<b>Office Action Summary</b>	<b>Application No.</b> 10/597,861	<b>Applicant(s)</b> GIORDANO, GIUSEPPE	
	<b>Examiner</b> Jack W. Lavinder	<b>Art Unit</b> 3677

## **DETAILED ACTION**

Claims 1-3 have been rejected under 35 U.S.C. 102(b) as being clearly anticipated by Kostka, 2555196.

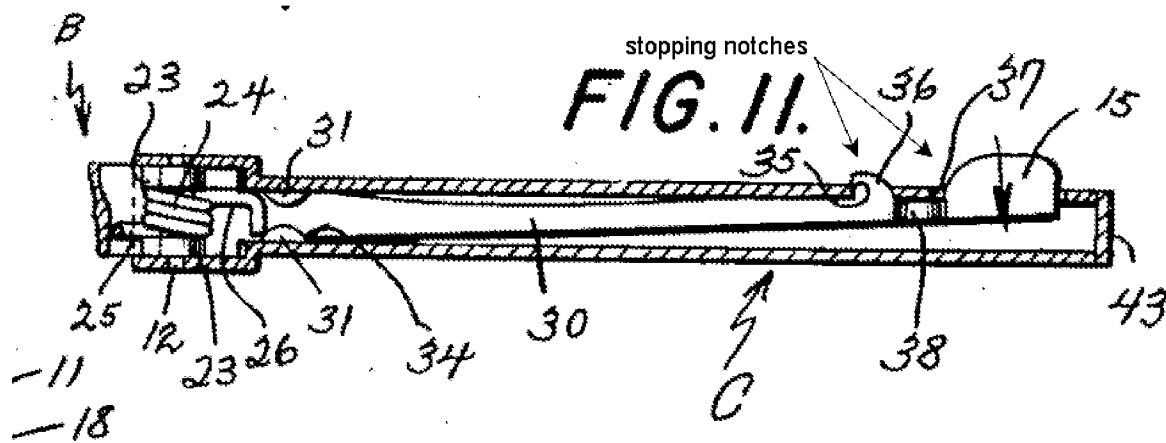
Regarding claim 3, see annotated drawing showing the stopping notches.
